**Request For Proposal 23-014 – Public Health Phase Two Building Improvements - Dated January 6, 2023**

**23-014 – Public Health South Phase 2 Building Improvements**

## Additional Questions RFP 23-014

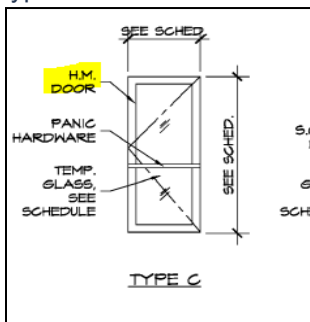
11. Floor plan A1.5 indicates construction note 1 (snap on door frame) at door 116A. Door schedule does not indicate this scope for this door. Please review and clarify if door no.116A requires a snap on door frame.

a. Yes, it should have a new snap on front frame.

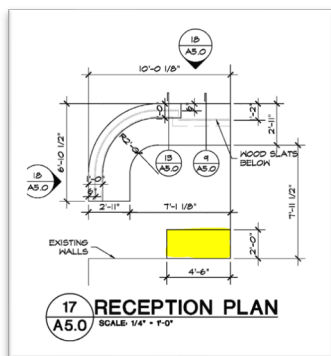
14. The door schedule lists door no. 134A and 134B as door type C "glass". The elevation of door type C calls for hollow metal with a full glass panel insert (see image below).

Please clarify if door no. 134A and 134B are intended as storefront doors (anodized aluminum) or hollow metal with a full glass panel.

a. Doors 134A and 134B are existing to remain. GC to provide card reader. EPC has already provided power. VTI to connect. Update on A1.6, A2.0

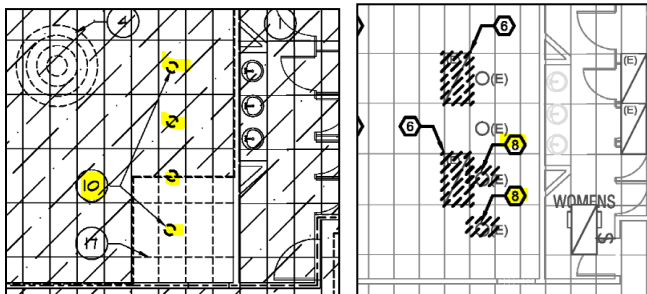
24. Construction note 7 calls for a new thermostat at 117 Exam Room. This scope is not indicated on the mechanical plan MD-H-101. S. Please review and clarify scope.

a. No thermostat.

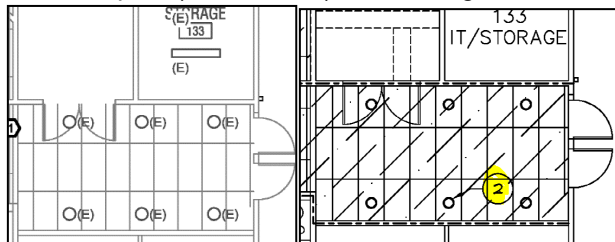
27. RCP note 10 on sheet A1.4 calls for removal of (4) light fixtures near new lactation room. Demolition note 8 on ED-L-101.S calls for removal of (2) light fixtures at this same location. See images below for reference.

We assume removal of (2) fixtures per electrical is correct. Please confirm or clarify if otherwise.

a. Yes, electrical is correct. Remove two fixtures and keep two fixtures. Update on A1.4.

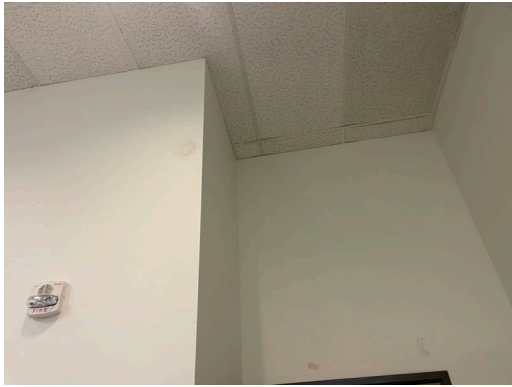
1. Ceiling grid edging to be added only to room 116, since it is partially completed. Please see pictures below.

2. No edging to be done on hallway 122 or room 124.
